**2.5 EQUIPMENT DEPLOYMENT
FALCON MIDDLE SCHOOL
PARCEL NUMBER: 5225300002**

DN70XC032
9755 TOWER AVE
PEYTON, CO 80831
LATITUDE: 38.97216944°
LONGITUDE: -104.6194056°
CONSTRUCTION DRAWINGS

SHEET NO.
T1.0
EPC PROJECT NUMBER: VA18-003

SHEET NO.
A1.0
 EPC PROJECT NUMBER: VA18-003

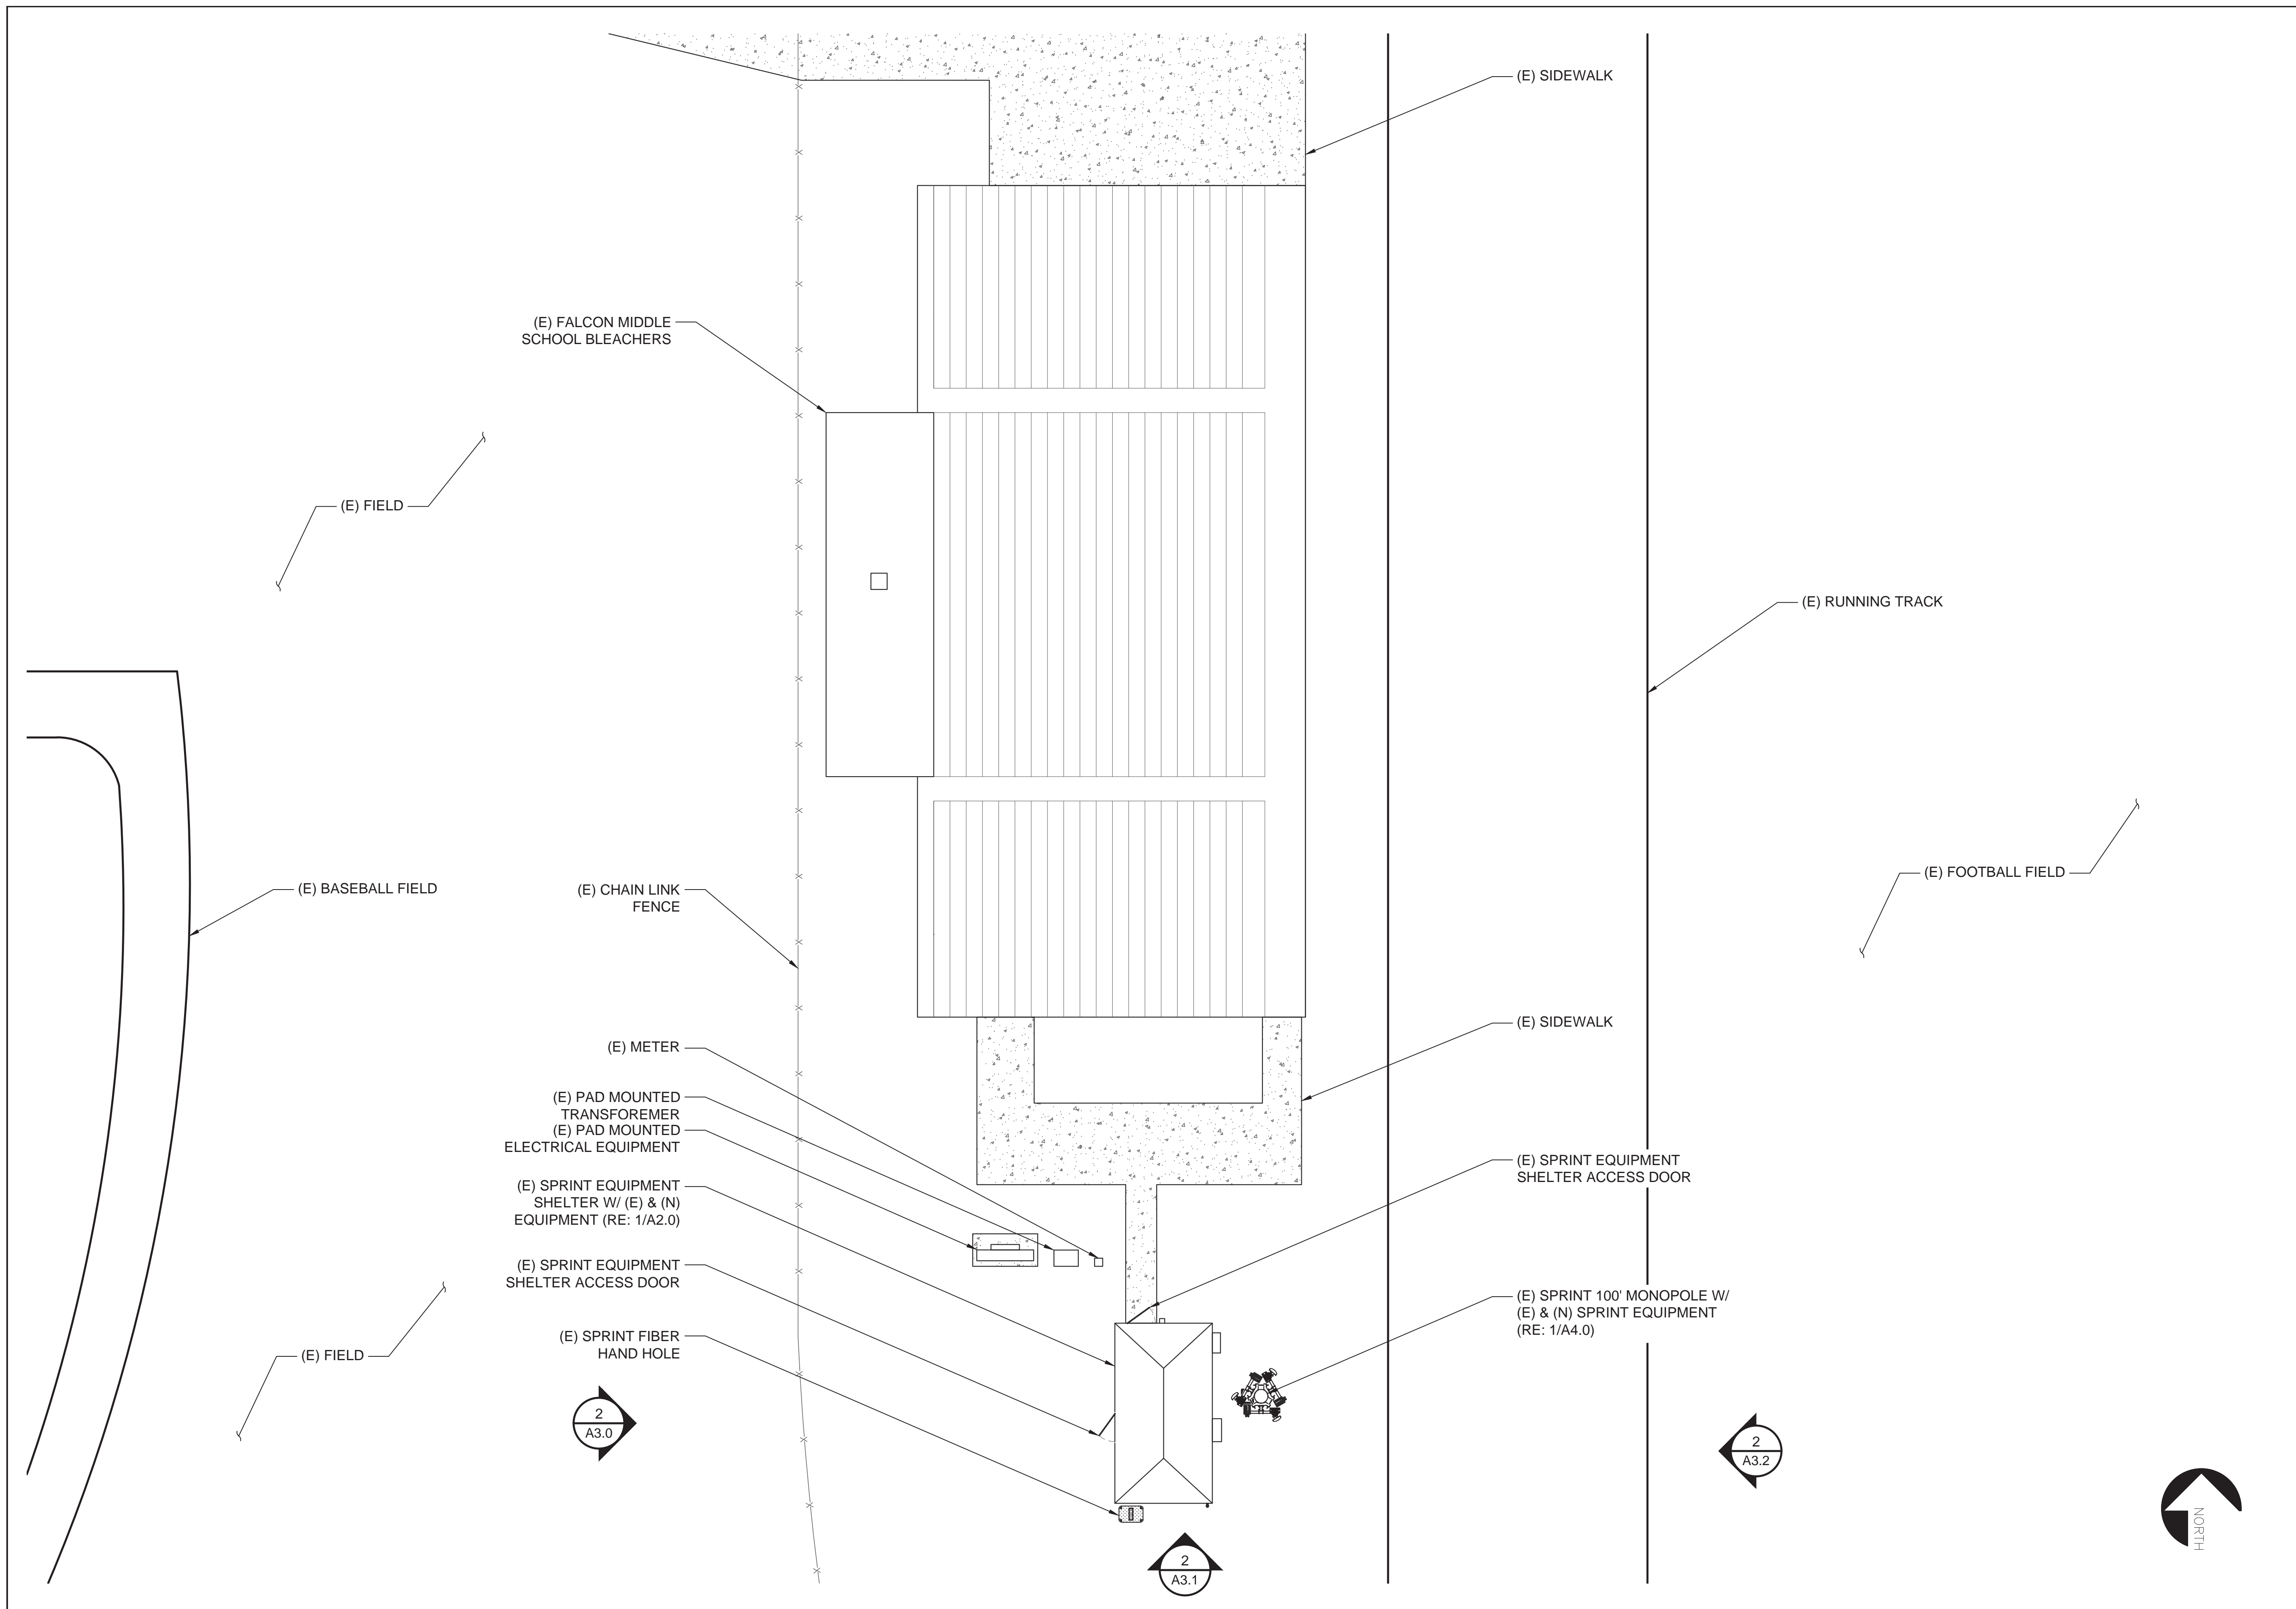
Include this Note:
 The parties responsible for this plan have familiarized themselves with all current accessibility criteria and specifications and the proposed plan reflects all site elements required by the applicable ADA design standards and guidelines as published by the United States Department of Justice. Approval of this plan by El Paso County does not assure compliance with the ADA or any regulations or guidelines enacted or promulgated under or with respect to such laws.
